**Subject:** [FI] S.16 Application No. A/YL-SK/371 - FI to address departemntal comments

**2<sup>nd</sup> Further Information**

**(S.16 Planning Application No. A/YL-SK/371)**

**Responses-to-Comments**

Drawing No. <b>V1053/003</b>	Stage Rev. <b>P A</b>
------------------------------	-----------------------

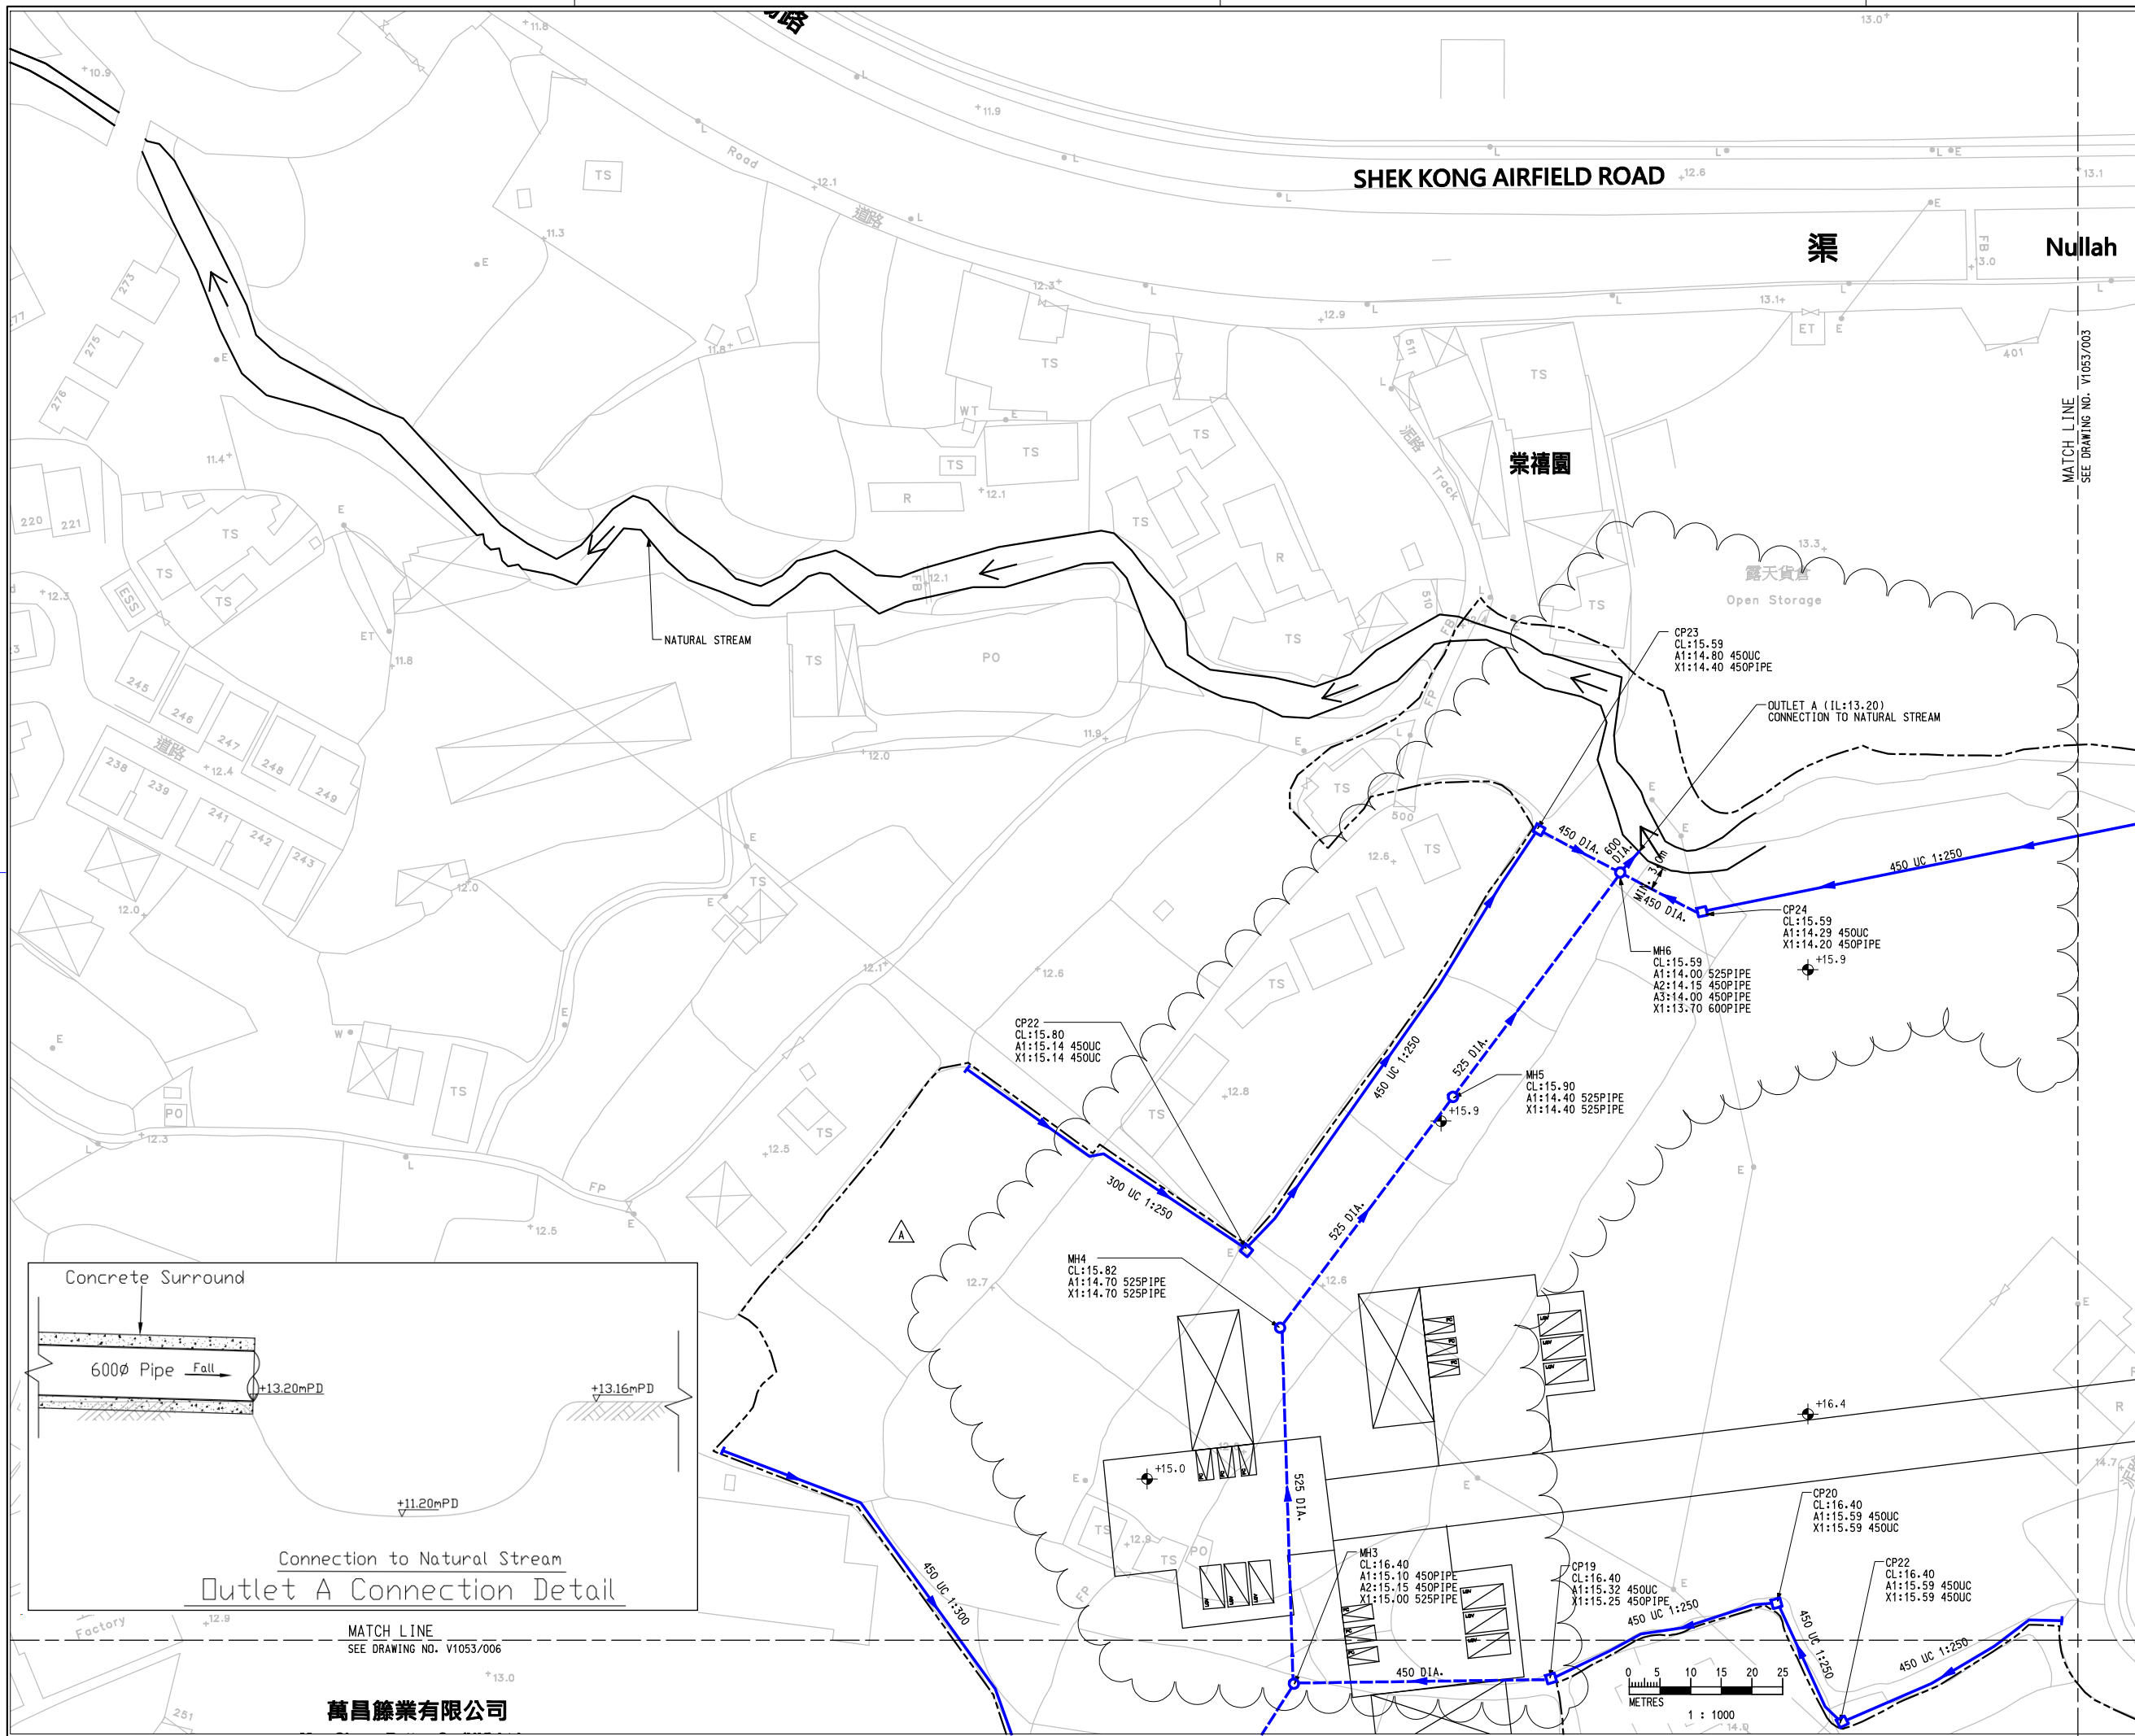
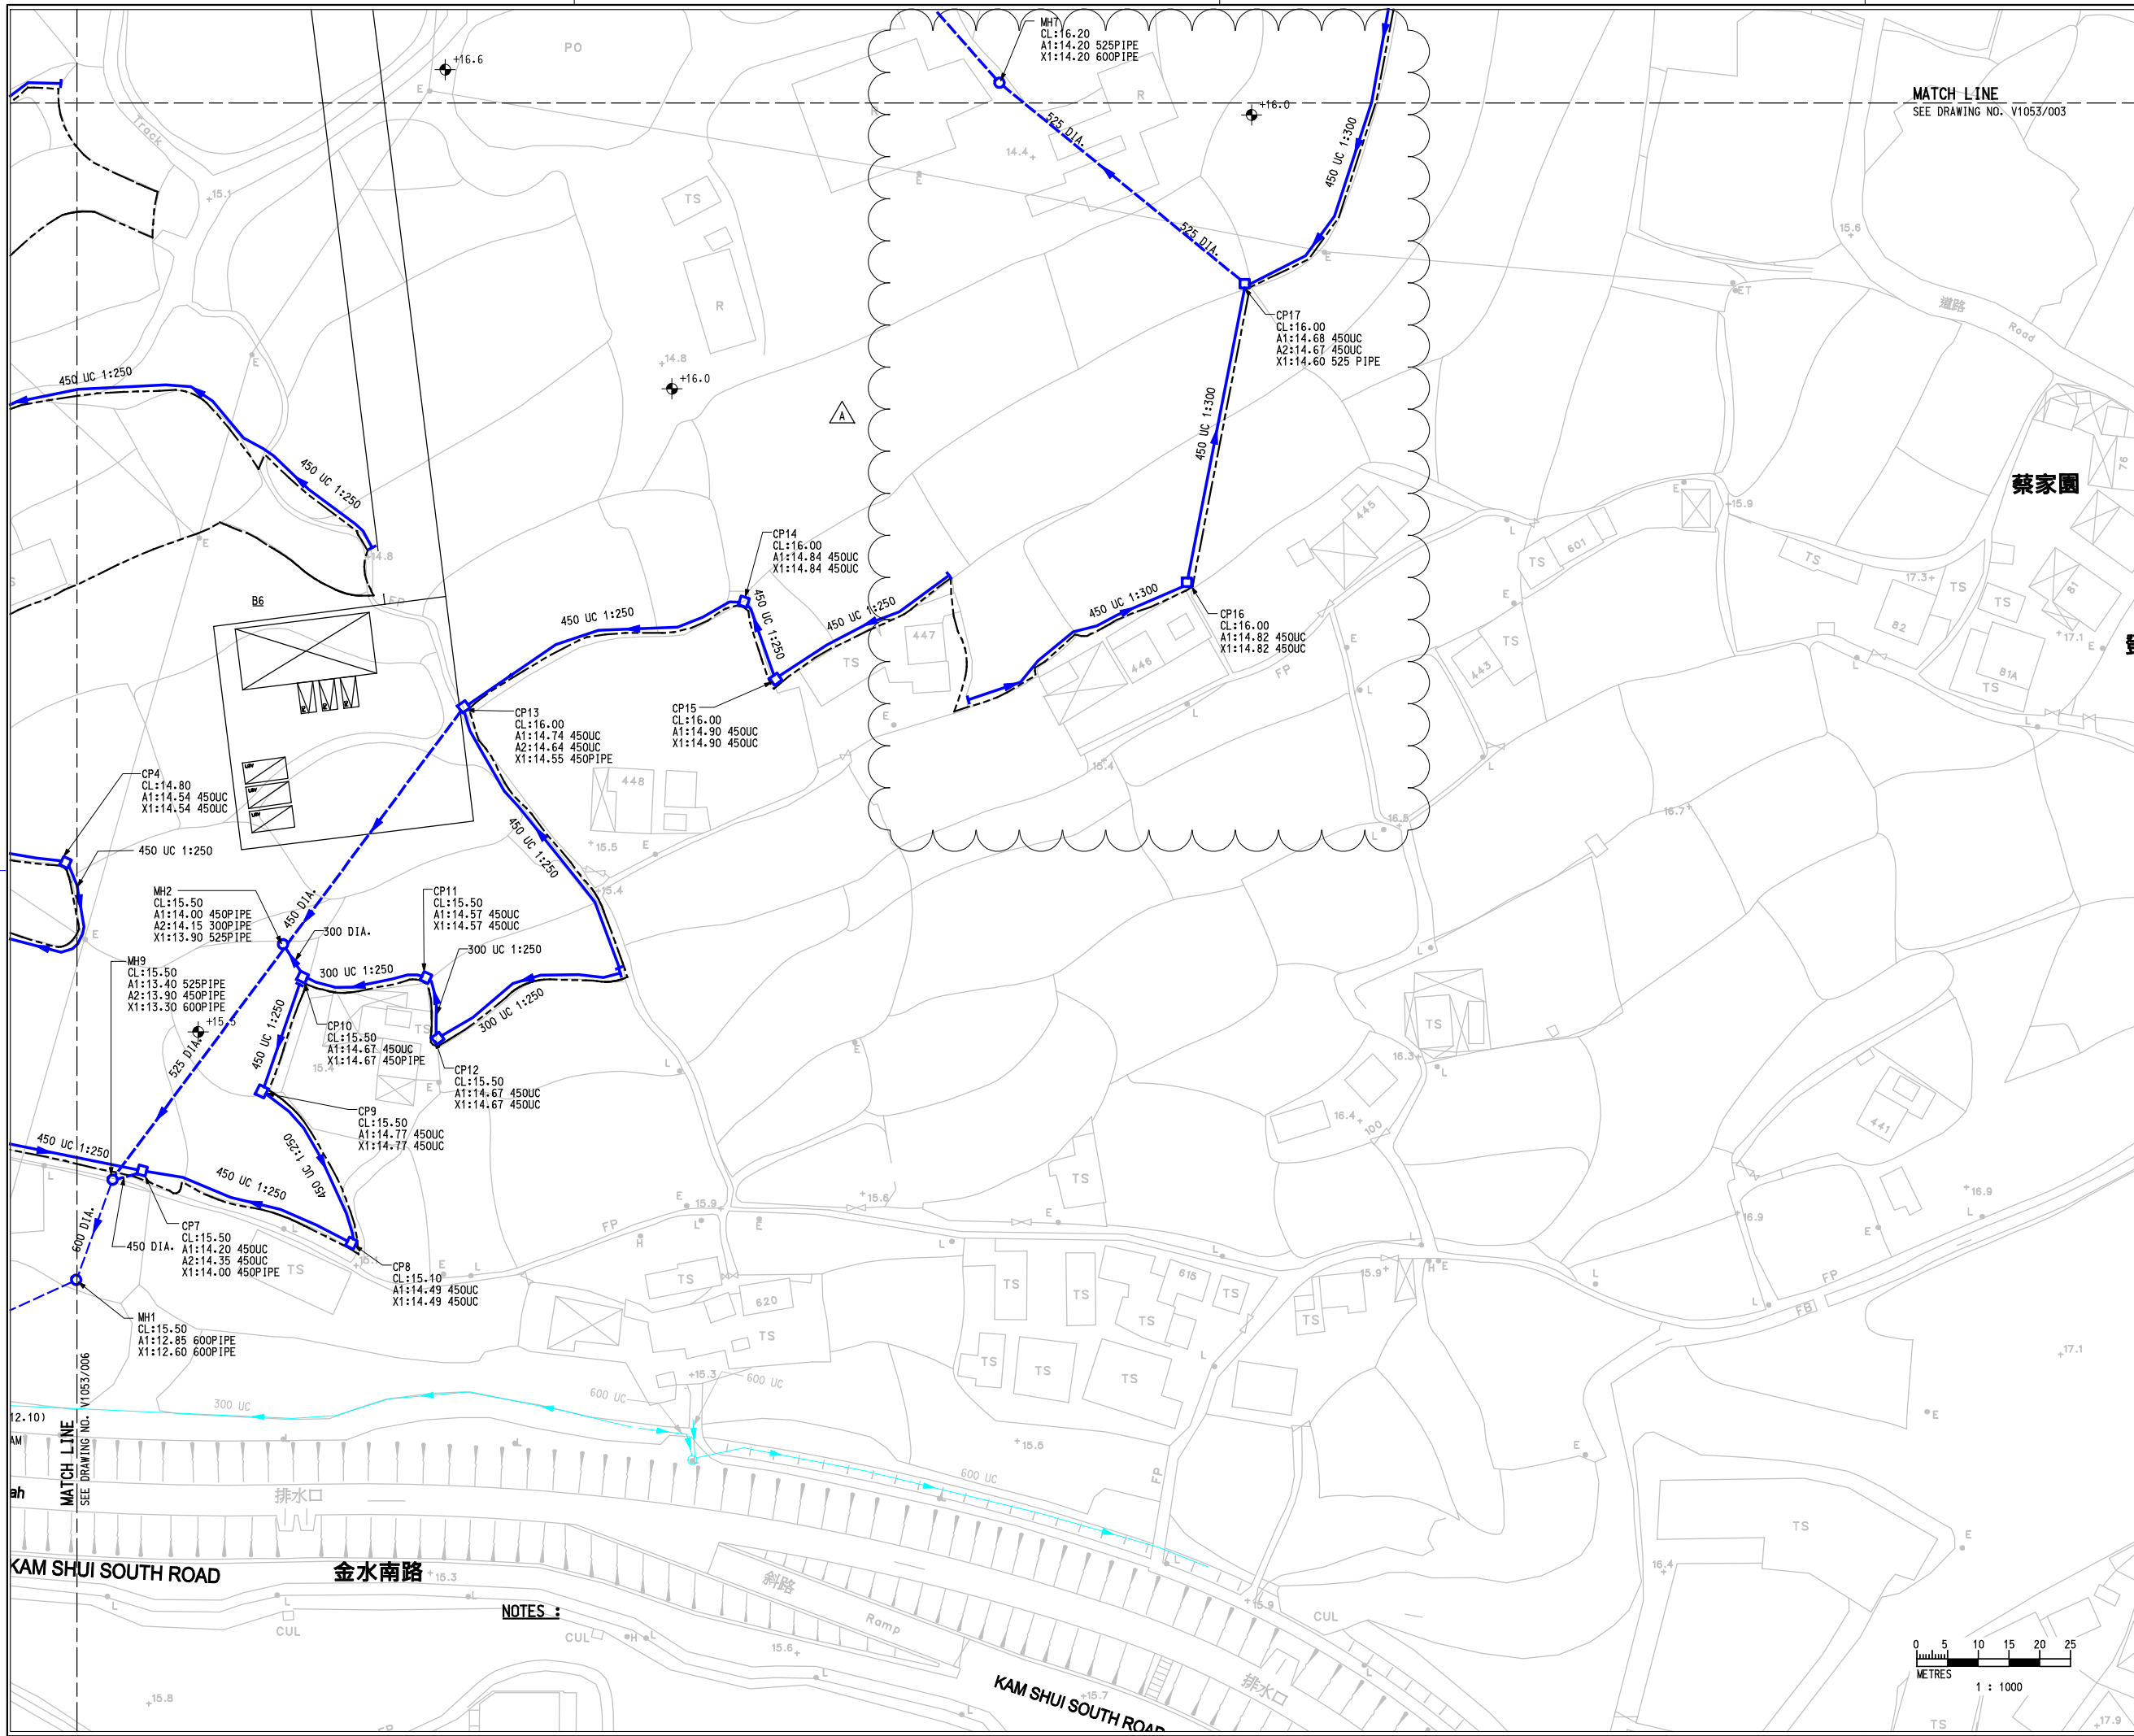
(b)	Please show the construction details as all discharge point and indicate all C.L., I.L and catchpit/streamcourse bottom level in the drawing.	Noted. The connection details at all discharge points are shown on Drawing No. V1053/003A~006A in Appendix A.
